Corrigendum 5 dated Dec' 06, 2019 to Tender Specification BHEL PSSR SCT 1866 for Structural Works of Coal Handling Plant and Ash Handling Plant area and Non-plant structure of Unit 1 & 2 (Package 2) for 2 x 660 MW Udangudi Supercritical Thermal Power Project, Tuticorin, Tamil Nadu

1) Some of the Bidders had raised queries for clarification in the published Tender Specification and BHEL's clarifications are furnished below:

SEA WATER OUTFALL PUMP SECTIONAL VIEW - 'A-A'
SCALE 1:160

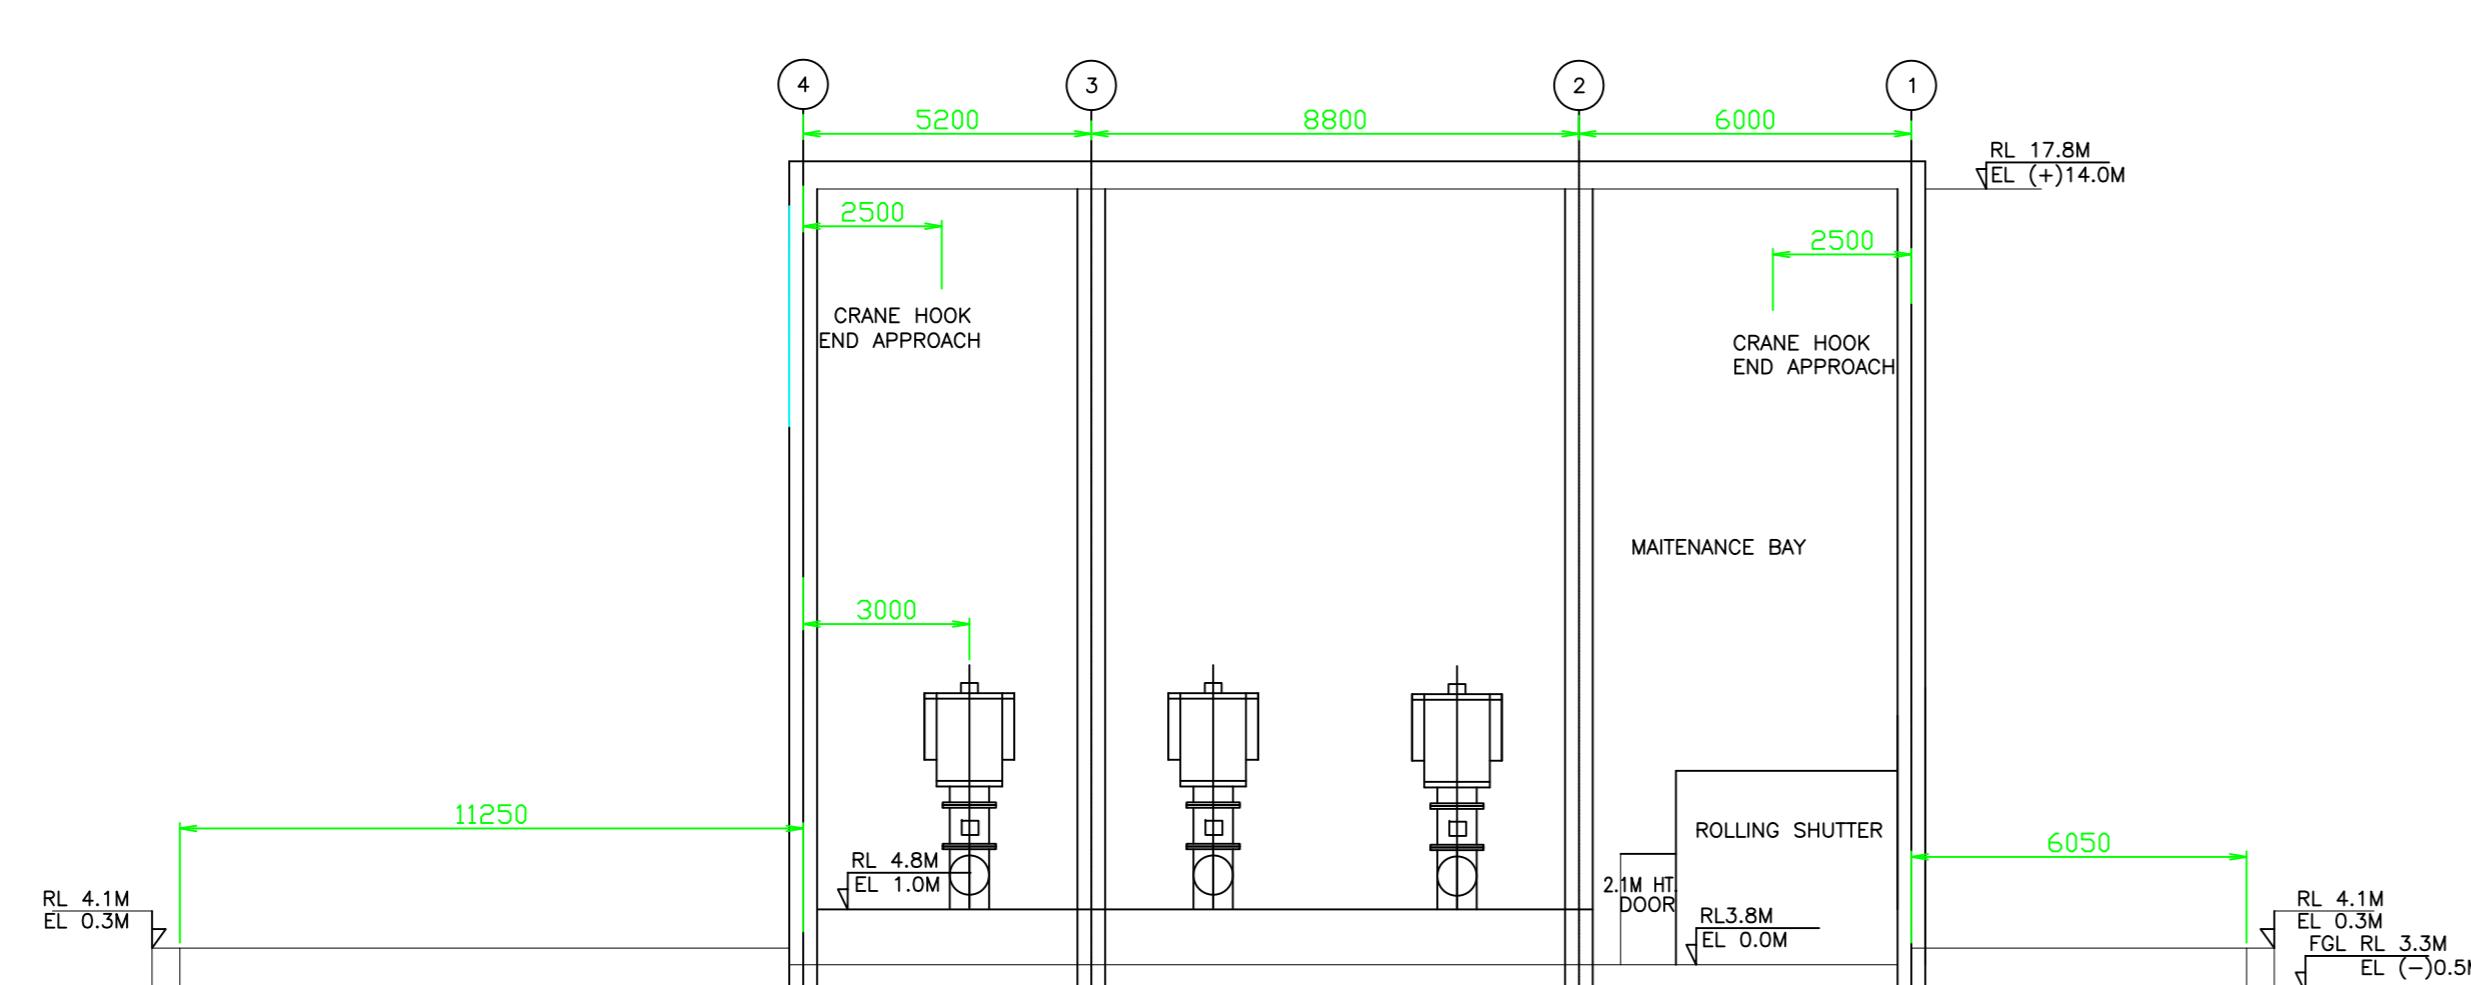
Quantity of each type of stop log and coarse screen	Refer Pricebid
9	Price Bid	Item A2329, B2329 , A2332, B2332	Size of each type of gate and screen	Refer enclosed drawing for information
			Max water level	
			Minimum water level	
			Sill level	
			Operating floor level	
			Opening of wire mesh and dia of wire mesh	
10	Part C: Bill of Quantities	Item no. 2303	The weightage allocated to this item seems to be unbalanced Weightage shall be revised for this item.	Tender Condition Prevails
